# STAFF RECOMMENDATION

NCPC File No. 7180/7075

## FORT BELVOIR – SOUTH POST NEW ADMINISTRATION BUILDING FOR THE UNITED STATES ARMY LEGAL SERVICES ADMINISTRATION AND ARMY AUDIT AGENCY

November 23, 2010

### **Rendering of the East Entrance to the Building and the Courtroom**

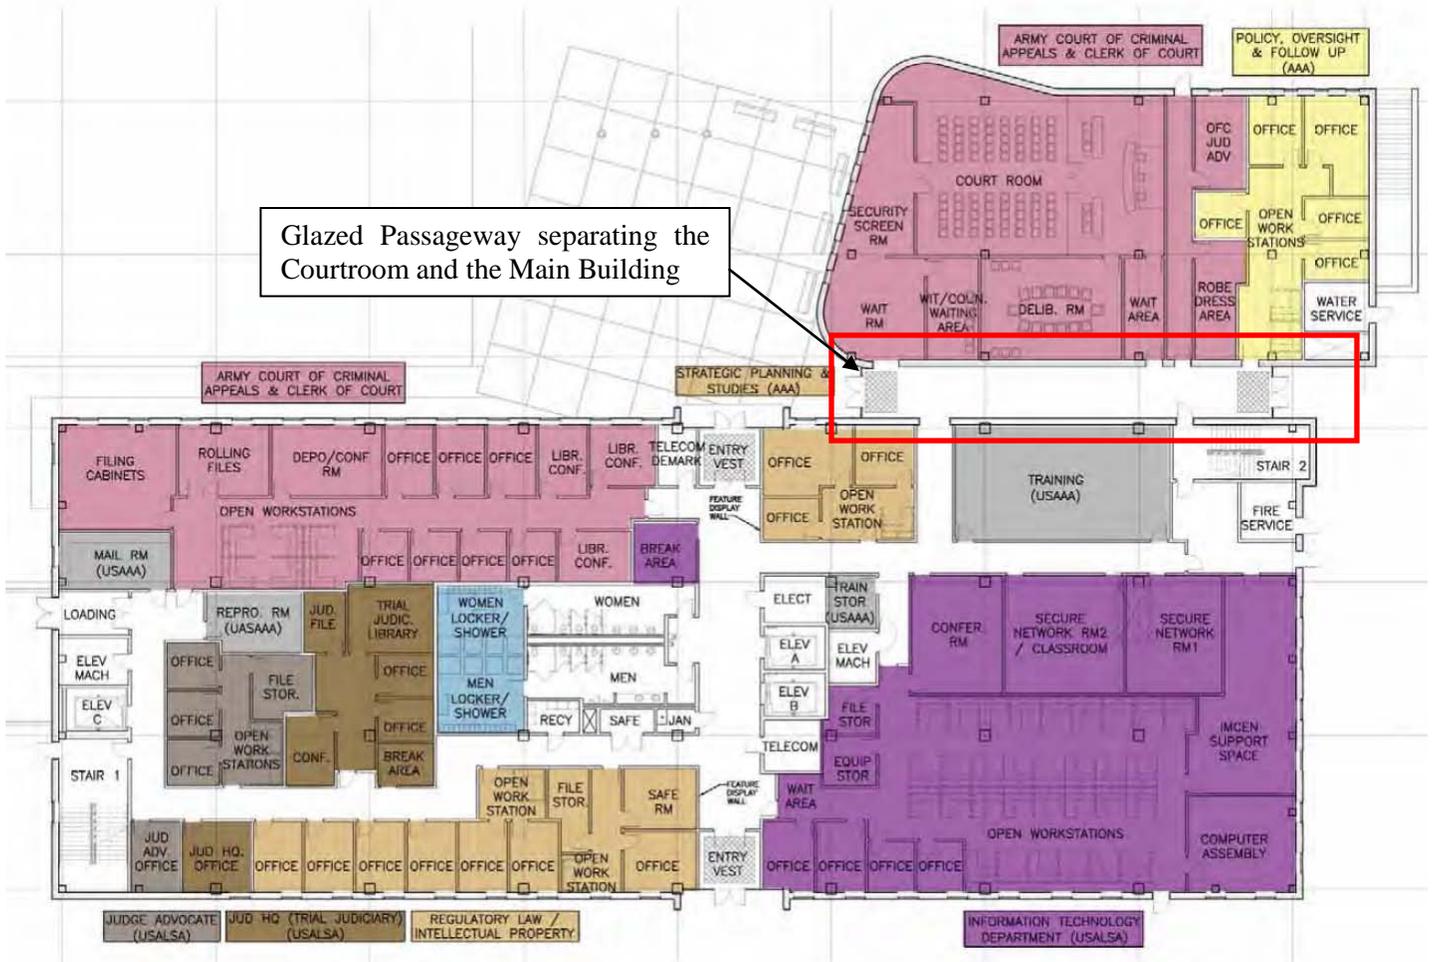
Staff encourages the Army and its design team to evaluate the design of the formal entrance to the building so that the entrance to the building is more prominent. The current design of the entrance causes the entrance to visually recede and is not easily recognizable as the formal entrance to the building.

- Redesign the Gunston Road entrance to make it more prominent
- Enhance pedestrian circulation by extending sidewalks along 4th Street and adding crosswalks at potential street crossings.
- Explore the use of vegetative walls on the proposed parking structure
- Address the comments submitted by Fairfax County, Virginia on November 4, 2010
- Add additional landscaping along Route 1 to screen potential views to the building from the Woodlawn Historic District.
